Development Review Staff Report

Howes Six Two Nine PDP 210008

HOWES SIX TWO NINE PDP ROUND TWO

HISTORIC PRESERVATION SECTION 3.4.7 COMPLIANCE
JUNE 8, 2021

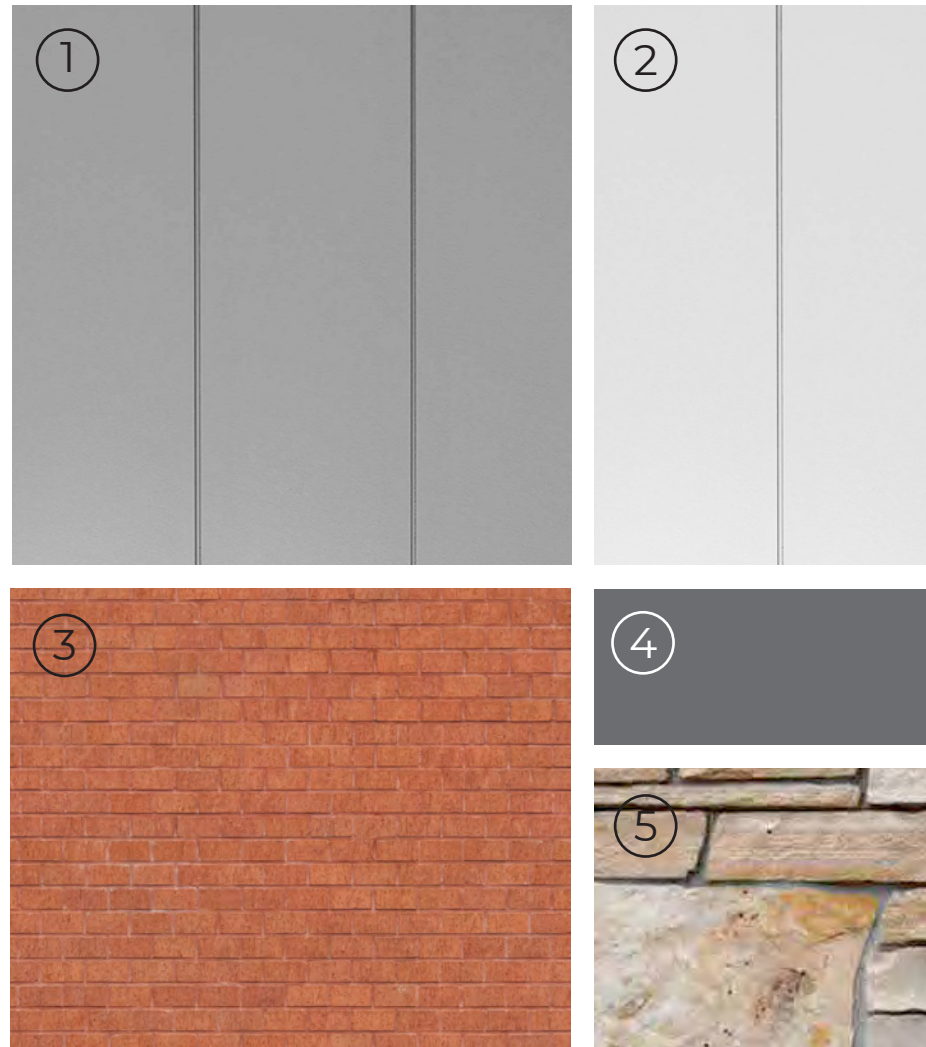
3. The lower story facades until any stepbacks (required or otherwise) must be constructed of **authentic, durable, high-quality materials** (brick, stone, glass, terra cotta, stucco (non EFIS), precast concrete, wood, cast iron, architectural metal) installed to industry standards.

RESPONSE

3. The street and courtyard facing facades of the ground level of the new building are clad in red brick with shingled areas to respond to the existing house and its later addition. Window sills/headers and the foundation walls of the existing house are sandstone with some painted wood frieze boards and trim while the one story addition is primarily clad with large scale shingles and horizontal siding. The new building design references these details throughout.

3.4.7 (E) TABLE 1 REQUIREMENT - BUILDING MATERIALS (CONTINUED)

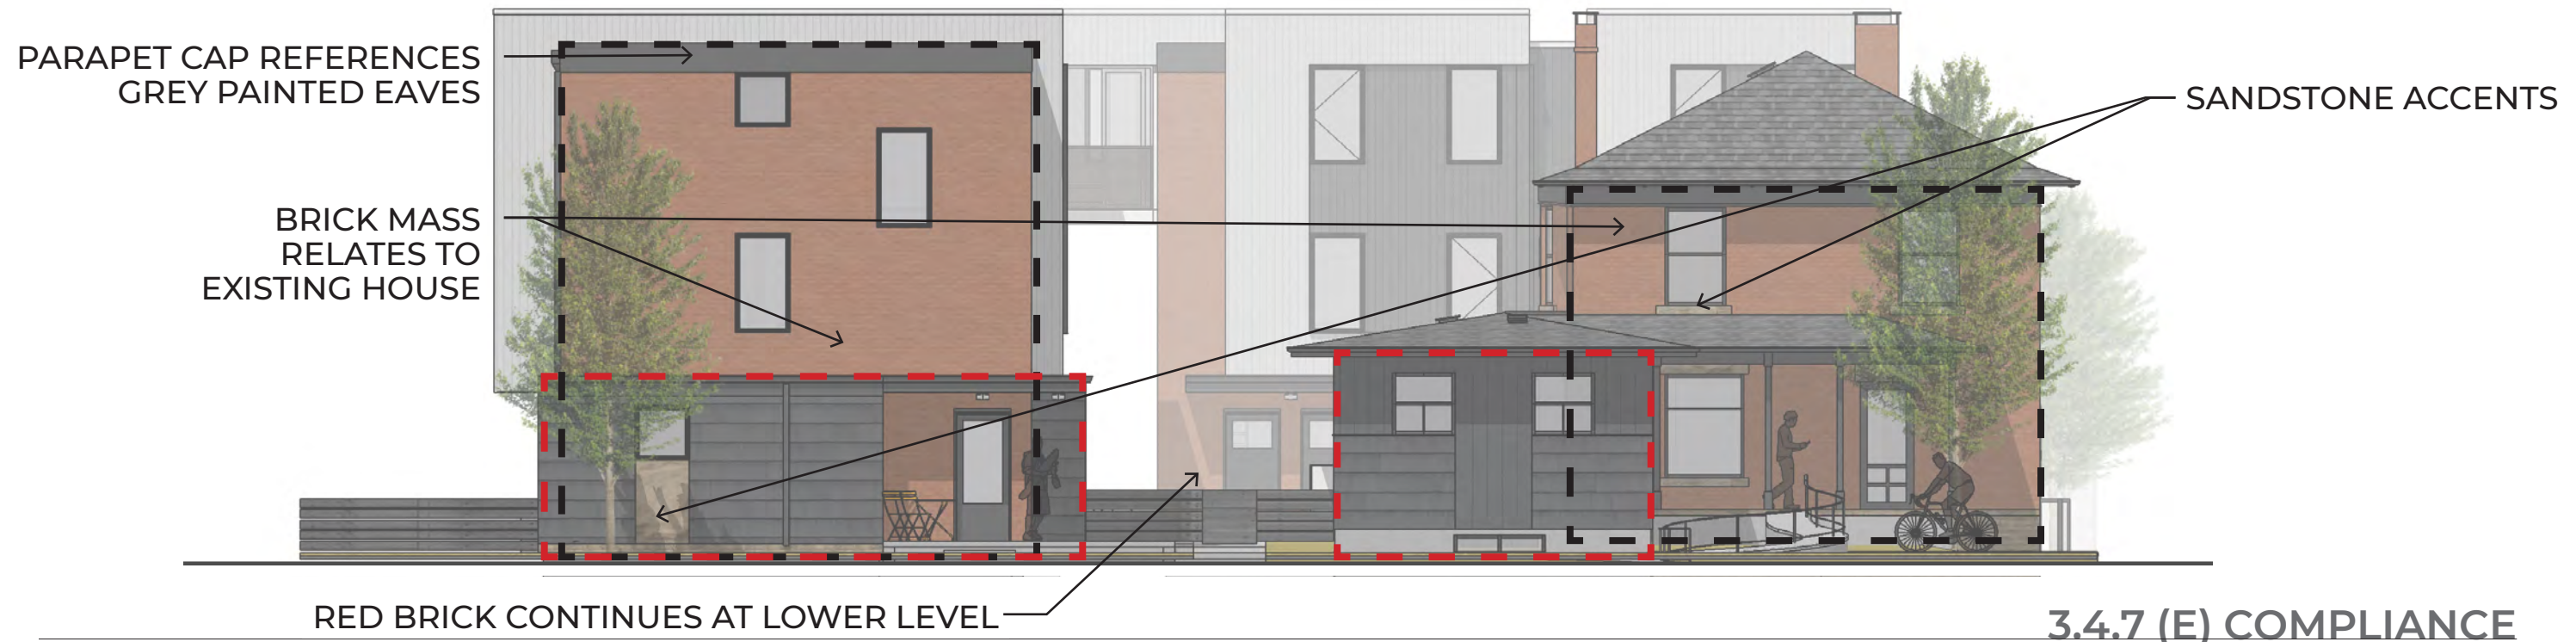
4. New construction shall reference one or more of the predominate material(s) on historic resources on the development site, abutting, or across a side alley, by **using at least two** of the following to select the primary material(s) for any one to three story building or the lower story facades until any stepbacks (required or otherwise):

RESPONSE

4. The street and courtyard facing facades of the ground level of the new building are clad in red brick with shingled areas to respond to the existing house and its later addition. Window sills/headers and the foundation walls of the existing house are sandstone with some painted wood frieze boards and trim while the one story addition is primarily clad with large scale shingles and horizontal siding. The new building design references these details throughout.
